New Port Facility Falkland Islands

Supporting statement to variation of condition application

Revision	Date	Description	Prep	Check	App
P02	24-Aug-2022	Final for planning submission	MS	RP	MS

Contract No:	Doc No:	Status	Revision
BAM	BAS.2051	BAS2051-RHD-ZZ-ZZ-FN-YE-5037	S4	P02
RHDHV	PB7829	PB7829-RHD-ZZ-ZZ-FN-YE-5037	S4	P02

WORKING QUAYSIDE NOW 300m

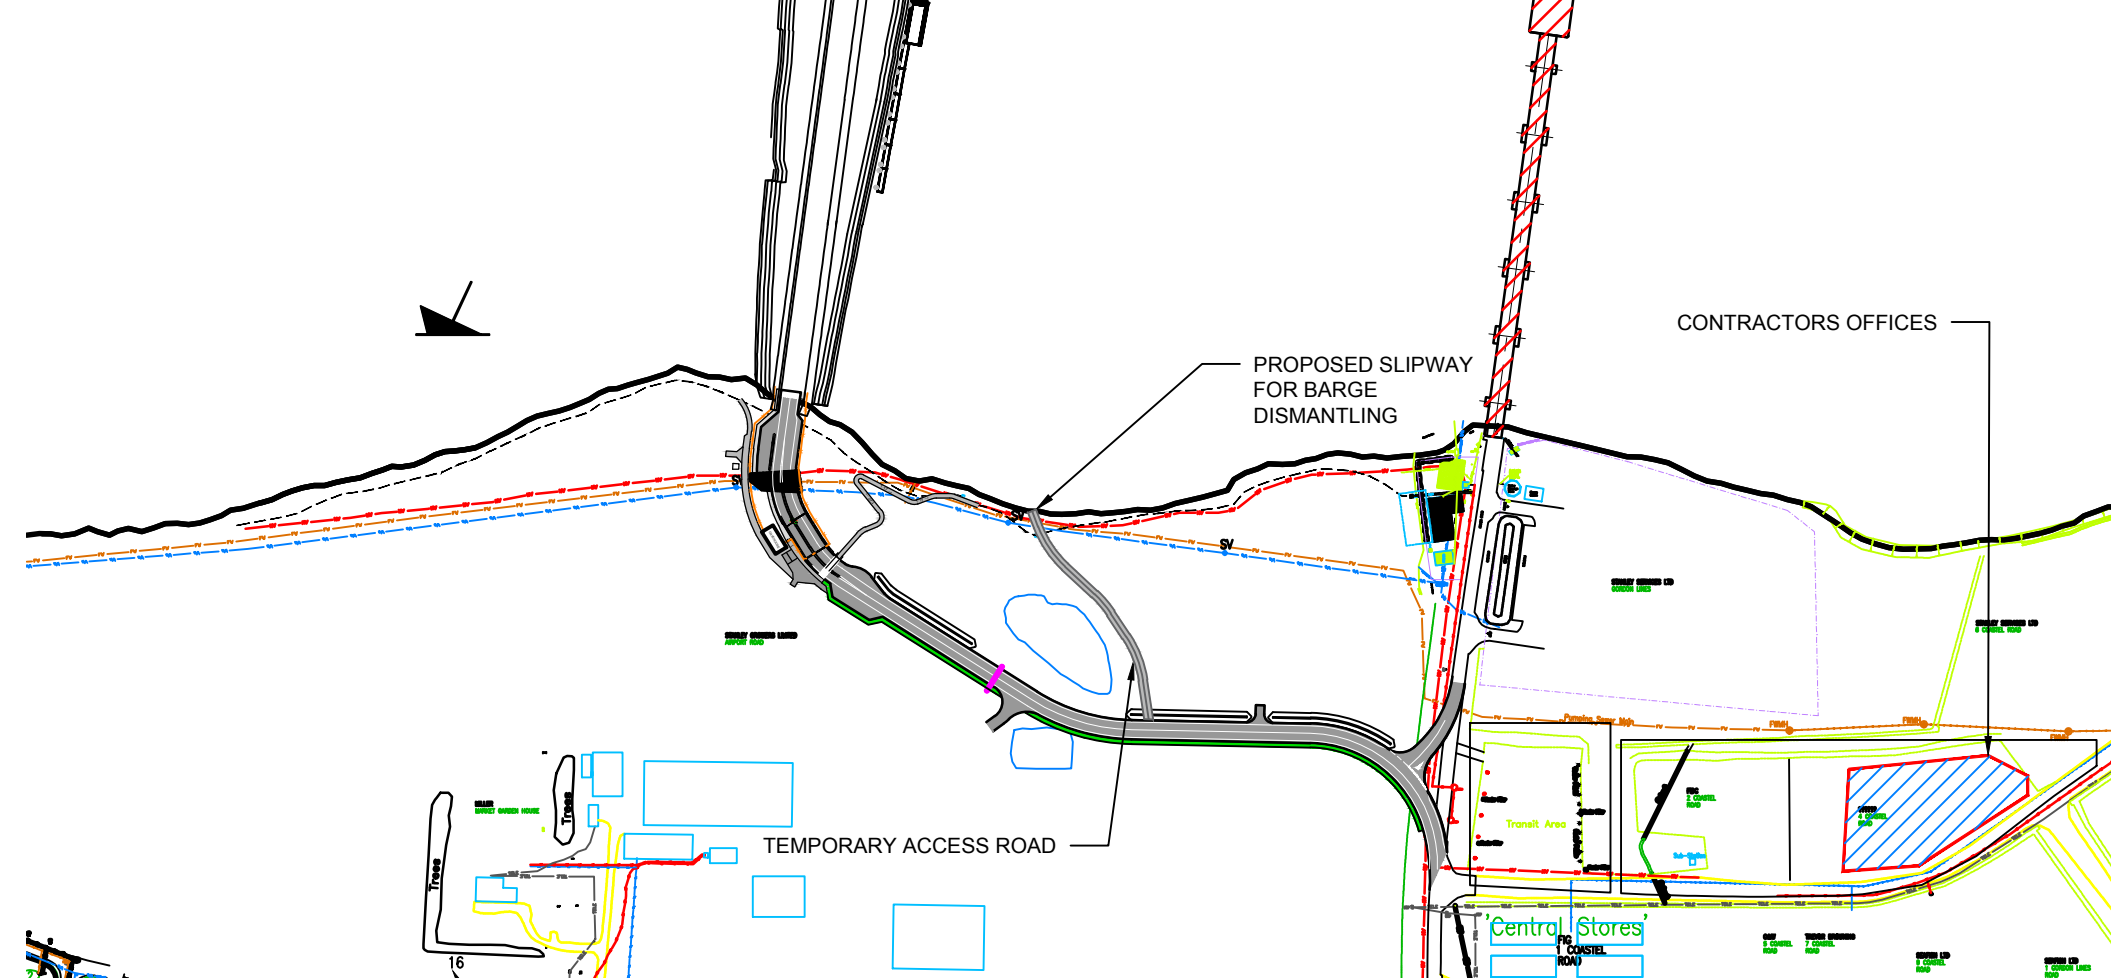
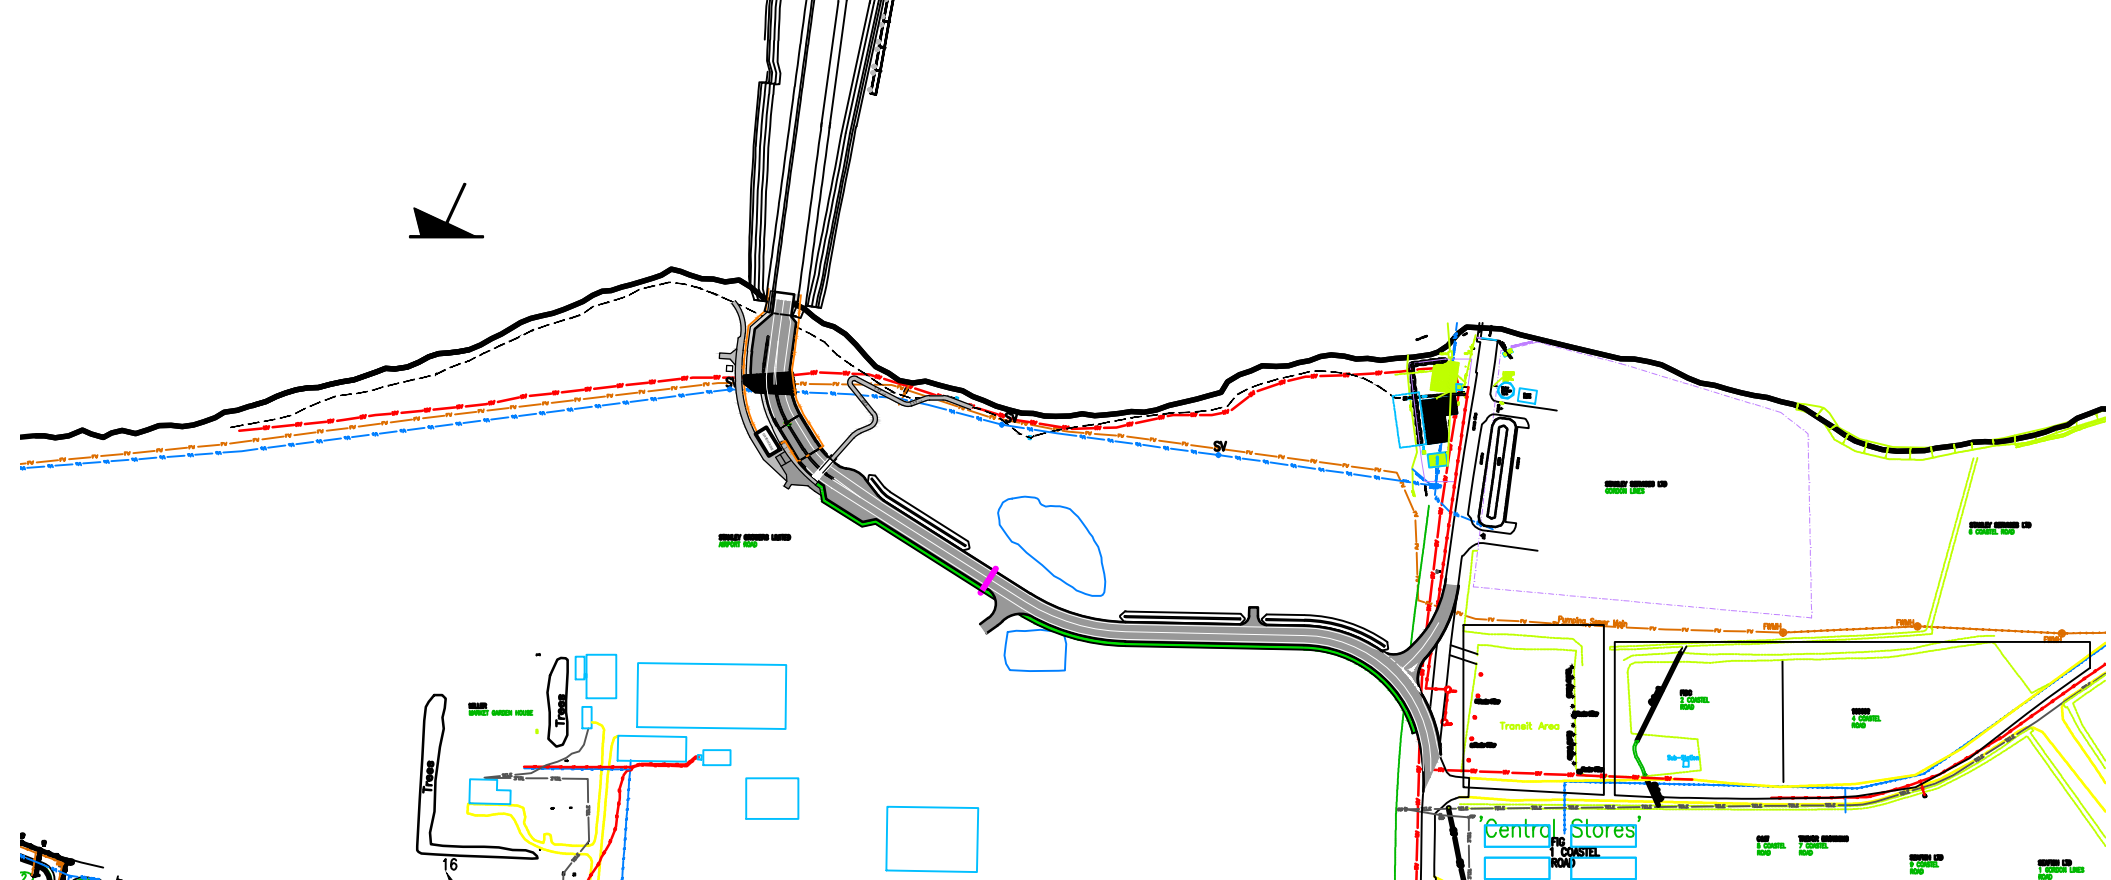
Variation to	Details	Primary condition or content affected
Drawings	Approved Plans updated, some of which are included as supporting drawings to the EIS.	Condition 2 – Approved Plans

DISMANTLEMENT STRATEGY DRAWING

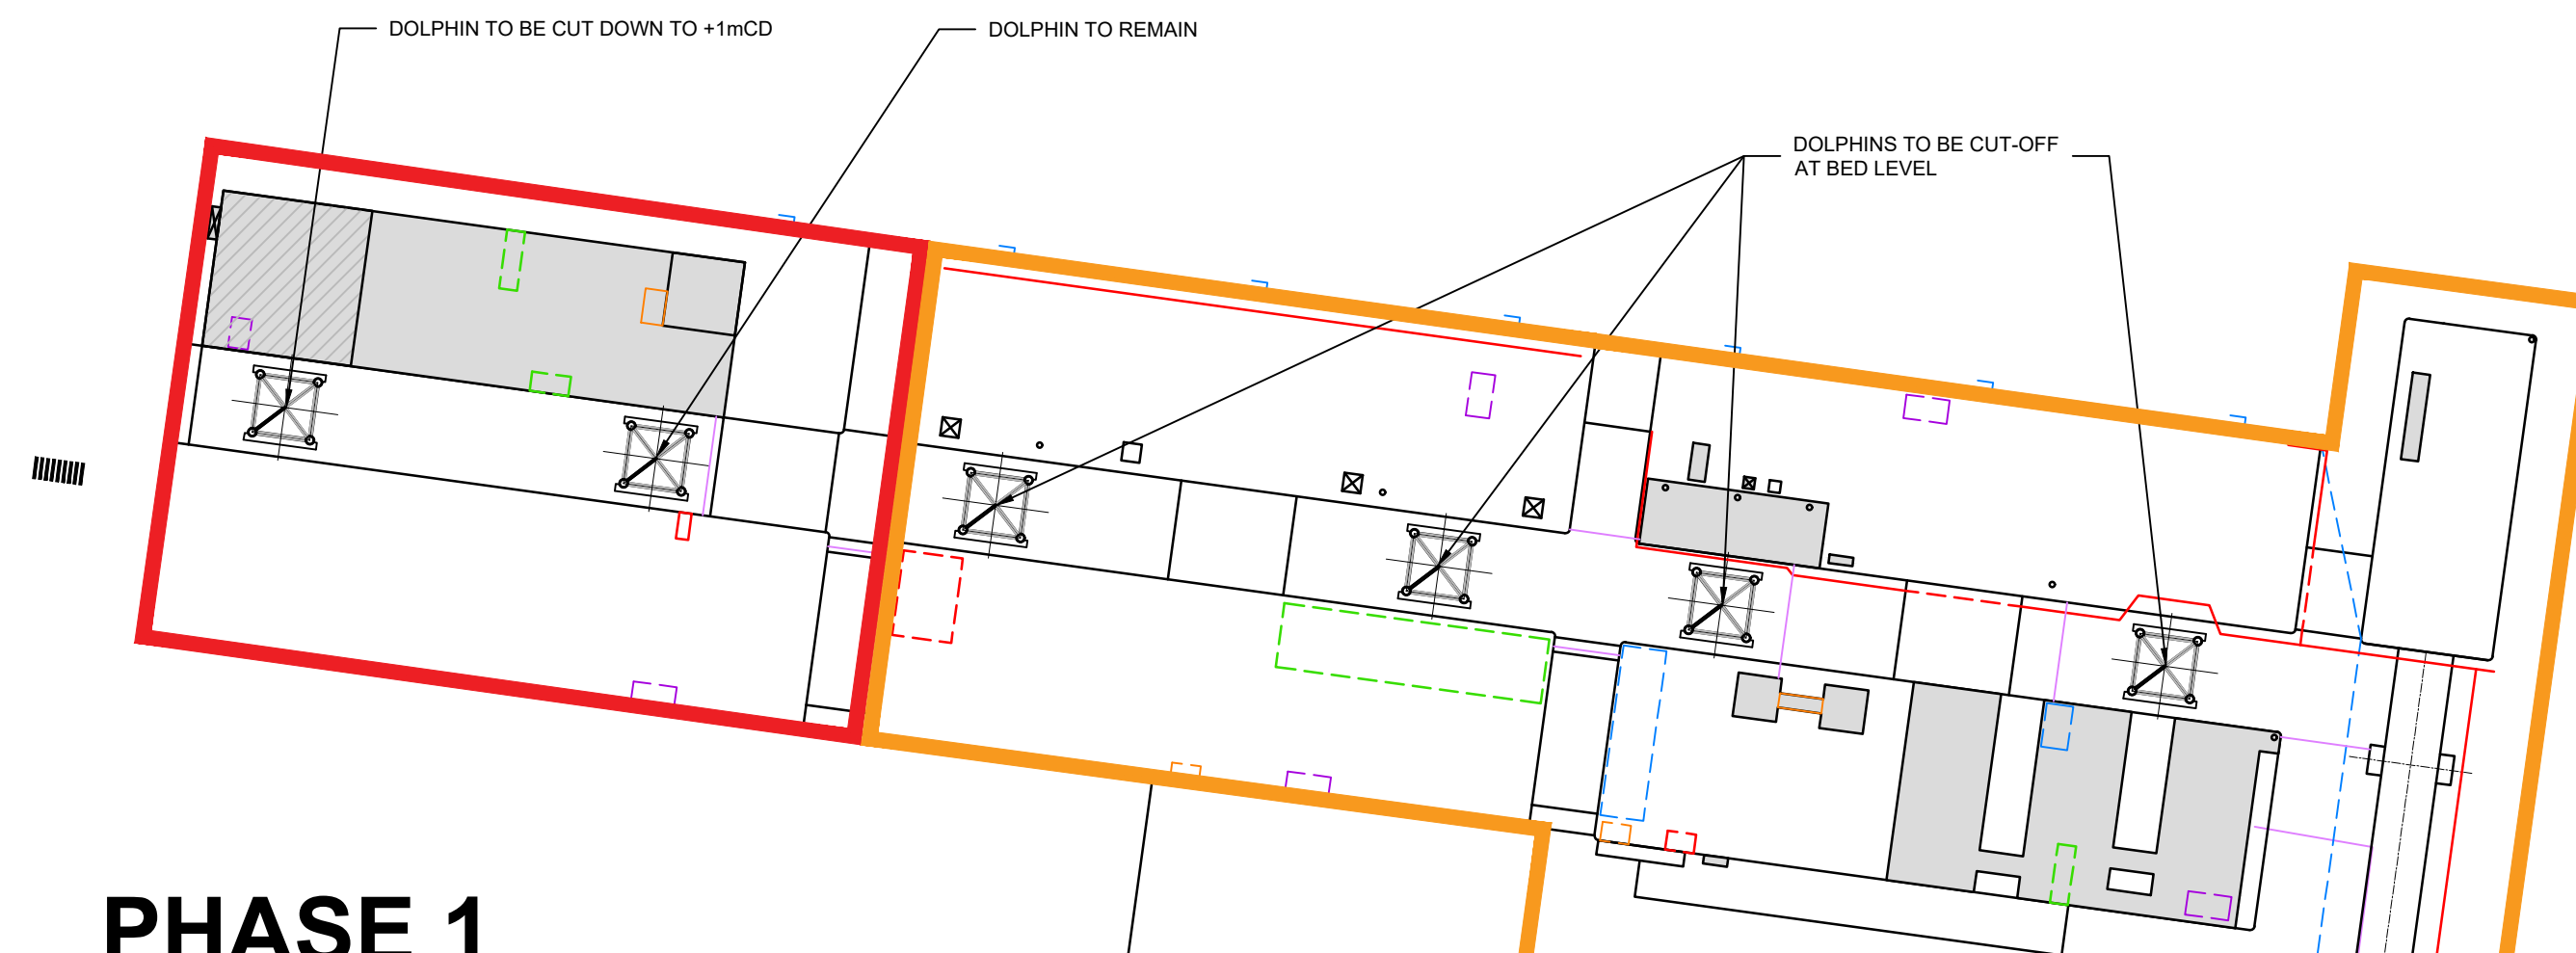
Variation to	Details	Primary condition or content affected
Towing/winching to land-based dismantling facility	This element is superseded due to the proposed scuttling of FIPASS.	Condition 2 – Approved Plans
Drawings	Approved Plans updated, some of which are included as supporting drawings to the EIS.	Condition 2 – Approved Plans

Variation to	Details	Primary condition or content affected
Dismantling of the FIPASS barges	<p>This process described for dismantling the FIPASS barges is superseded due to the proposed scuttling of FIPASS.</p> <p>For the scuttling approach, as part of the construction sequence the barges will be temporarily relocated either to a zone to the east of the existing FIPASS causeway or to the south of FIPASS and re-ballasted so that they sit within the seabed sediments. The purpose of this activity is to manage marine INNS on the base and lower sides of the barges.</p>	<p>Condition 2 – Approved Plans</p> <p>Condition 4 - Construction Works – Construction Environmental Management Plan</p>

Variation to	Details	Primary condition or content affected
Causeway dismantlement	This element is superseded due to the proposed scuttling of FIPASS.	Condition 2 – Approved Plans
Drawings	Approved Plans updated, some of which are included as supporting drawings to the EIS.	Condition 2 – Approved Plans
